APPLICATION NO.	FILING DATE	FIRST NAMED INVENTOR	ATTORNEY DOCKET NO.	CONFIRMATION NO.
10/634,227	08/05/2003	Don E. Juliano	48916-01010	6517
34013	7590 06/16/2006		EXAMINER	
HOLME ROBERTS & OWEN, LLP			LHYMN, EUGENE	
299 SOUTH MAIN SUITE 1800			ART UNIT	PAPER NUMBER
SALT LAKE	CITY, UT 84111		3727	<u>-</u>
			DATE MAILED: 06/16/2006

Application No.	Applicant(s)			
	10/634,227	JULIANO ET AL.			
Office Action Summary	Examiner	Art Unit			
·	Eugene Lhymn	3727			
The MAILING DATE of this communication app ars on the cov r sheet with the correspond nce address Period for Reply					
A SHORTENED STATUTORY PERIOD FOR REPLY WHICHEVER IS LONGER, FROM THE MAILING DA - Extensions of time may be available under the provisions of 37 CFR 1.13 after SIX (6) MONTHS from the mailing date of this communication. - If NO period for reply is specified above, the maximum statutory period was preply received by the Office later than three months after the mailing earned patent term adjustment. See 37 CFR 1.704(b).	ATE OF THIS COMMUNICATION 36(a). In no event, however, may a reply be time rill apply and will expire SIX (6) MONTHS from cause the application to become ABANDONE	I. lely filed the mailing date of

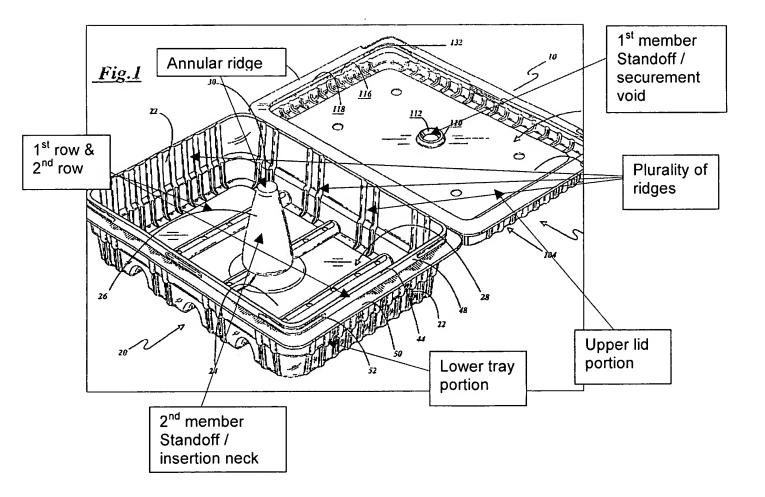
- 2. Claims 1-6, 34, 35, 8-16 are rejected under 35 U.S.C. 103(a) as being unpatentable over Krupa (US 5456379) in view of Merzweiler (US 3986299). With respect to claim 1, Krupa discloses the following:

- A lower tray portion (Fig. 1 below)
 - An upper lid portion, the upper lid portion being configured to overlay and be securely coupled to the lower tray portion so as to substantially enclose objects positioned between the lower tray portion and the upper lid portion (Fig. 1 below)

- One or more standoffs positioned between the lower tray portion and the upper lid portion to maintain a desired displacement between the a top surface of the upper lid portion and a bottom extremity of the lower tray portion, wherein each of the one or more standoffs providing a coupling adapted to minimize movement of the upper lid portion relative to the lower tray portion (Fig. 1 below)

With respect to claim 3, Krupa discloses one of more standoffs comprising a first and second member (Fig. 1 below).

With respect to claim 4, Krupa discloses the first member of the standoff being coupled to the upper lid portion (Fig. 1 below).

With respect to claim 5, Krupa discloses the second member of the standoff being coupled to the lower tray portion (Fig. 1 below).

With respect to claim 34, Krupa discloses a first and second row arranged on the lower tray portion, said first row and second row being separated, and the at least one standoff being positioned between said first and second row (Fig. 1 below).

With respect to claim 8, Krupa discloses the standoff's first and second members having lateral surfaces (Fig. 1 below).

- A lower tray portion, the lower tray portion being configured to at least partially enclose objects positioned therein (Fig. 1 below)
- An upper lid portion, the upper lid portion being configured to overlay and be securely coupled to the lower tray portion so as to substantially enclose objects positioned between the lower tray portion and the upper lid portion (Fig. 1 below)
- One or more standoffs positioned between the lower tray portion and the upper lid portion to maintain a desired displacement between the a top surface of the upper lid portion and a bottom extremity of the lower tray portion, each of the one or more standoffs comprising a first and second member which providing a snapcoupling (Fig. 1 below)

With respect to claim 10, Krupa discloses the lower tray portion including a plurality of enclosure rows, as shown in Fig. 1.

With respect to claim 14, Krupa discloses the first member of the standoff having an annular ridge and insertion neck (Fig. 1 below).

With respect to claim 15, Krupa discloses the second member of the standoff including a securement void (Fig. 1 below).

With respect to claim 35, Krupa discloses the first and second row being arranged on the lower tray portion, said first and second row being separated, the second member of the standoff being arranged between the first and second rows (See Fig.1 below).

Fig. 2

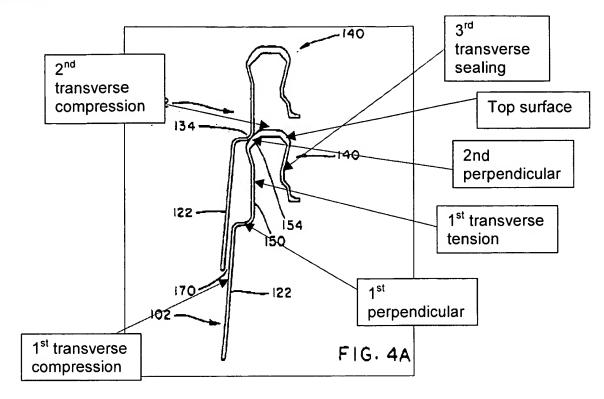
- A first transverse compression sealing surface (Fig. 2 below)
- A first perpendicular surface positioned adjacent to the first transverse compression sealing surface(Fig. 2 below)
- A transverse tension sealing surface adjacent the first perpendicular surface(Fig. 2 below)
- A second perpendicular surface positioned adjacent the transverse tension sealing surface(Fig. 2 below)
- A second transverse compression sealing surface adjacent the second perpendicular (Fig. 2 below)
- A top surface adjacent the second transverse compression
- A third transverse sealing surface(Fig. 2 below)

With respect to claim 28, Krupa, as modified above by Tucker, discloses the compression sealing surface of the first member engaging the compression sealing surface of the second member, the tension sealing surface of the first member engaging the tension sealing surface of the second member, and the lateral sealing surface of the first member engaging the lateral sealing surface of the second member, as shown in Fig. 2 below.

With respect to claim 29, Krupa, as modified above by Tucker, discloses wherein one or more of the sealing surfaces of the first and second member comprise transverse surfaces that provide a combination of resistance to lateral forces and either compressive forces or tensile forces (Fig. 2 below).

With respect to claim 30, Krupa, as modified above by Tucker, discloses the first member including a first transverse compression surface, a first perpendicular surface, a transverse tension, a second perpendicular, a second transverse compression, a top, and a third sealing surface (Fig. 2 below).

With respect to claim 31, Krupa, as modified above by Tucker, discloses the same structure as recited in claim 30, but the structure being on a second member (See Fig. 2 below).
